3.2 5 & 5A Wyuna Avenue Freshwater - Construction of Two Dwelling Houses with Associated Swimming Pools

SECTION 82A REVIEW OF DETERMINATION REPORT

Assessment Officer:	Kevin Short/Eleanor Robertson
Address / Property Description:	Lot 22 and 23, DP 5302 No.5 and 5A Wyuna Avenue, Freshwater
Proposal:	Construction of two (2) dwelling houses with associated swimming pools
Application No:	Rev2010/0012
Development Application No:	DA2009/1616
Application Lodged:	28 April 2010
Plans Reference:	01B to 03B, 04C to 08C prepared by Wolski Coppin Architecture, dated 27/4/10
Amended Plans:	NO
Applicant:	P and D Crowther
Owner:	P and D Crowther
Locality:	H1 Freshwater Beach
Category:	Category 1 (Housing)
Draft WLEP 2009 Permissible or Prohibited Land use:	Permissible – R2 Low Density Residential
Variations to Controls (Cl.20/Cl.18(3)):	YES (Building Height – ceiling, Side Boundary Envelope and Landscape Open Space)
Referred to ADP:	YES (More than 2 unresolved objections)
Referred to WDAP:	NO
Land and Environment Court Action:	NO
SUMMARY	
Submissions:	Four (4) submissions

C	27-04-2010	GENERAL AMENDMENT	2923	07C
B	13-04-2010	GENERAL AMENDMENT		
ISSUE DATE PROJECT PLOT DATE 27/04/2010 SCALE 1:100@A1			DRAWING NO	DA
AMENDMENT

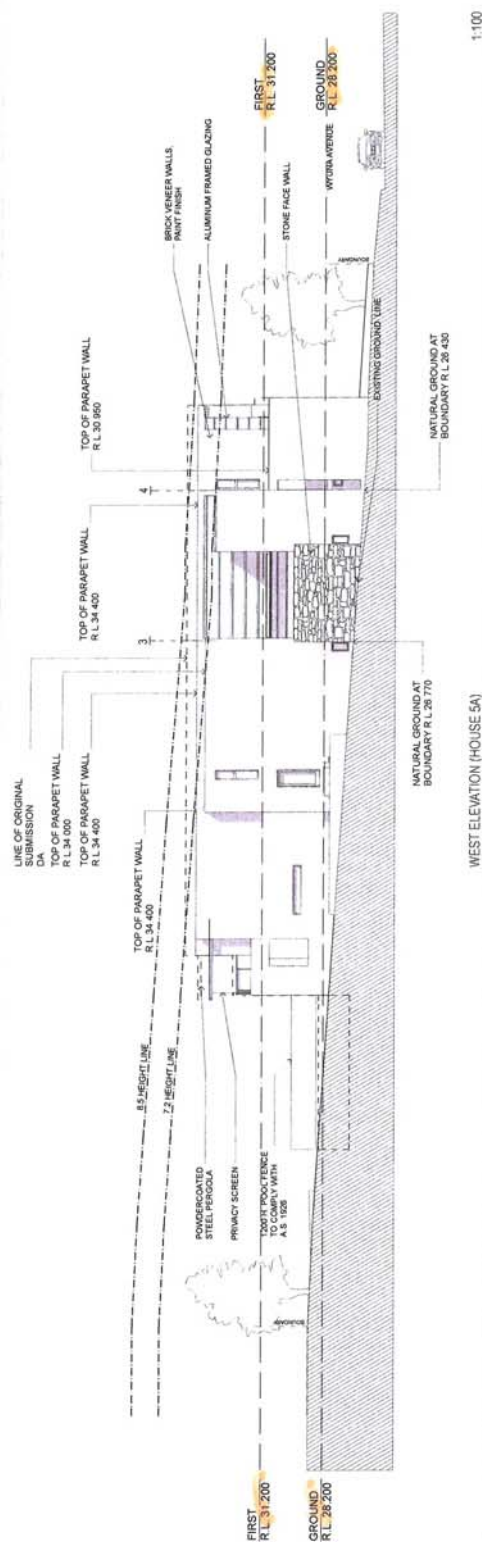
Comment: Concern has been raised regarding the accuracy of the revised plans submitted with the Section 82A application. In this regard, the West Elevation (Dwelling 5) on Drawing No.08C and the West Elevation (Dwelling 5A) on Drawing No.07C, incorrectly shows the location of the swimming pool and associated swimming pool fence. However, the location of the swimming pool and fence are correctly shown on the Ground Floor Plan (Site Plan), being Drawing No.02B.
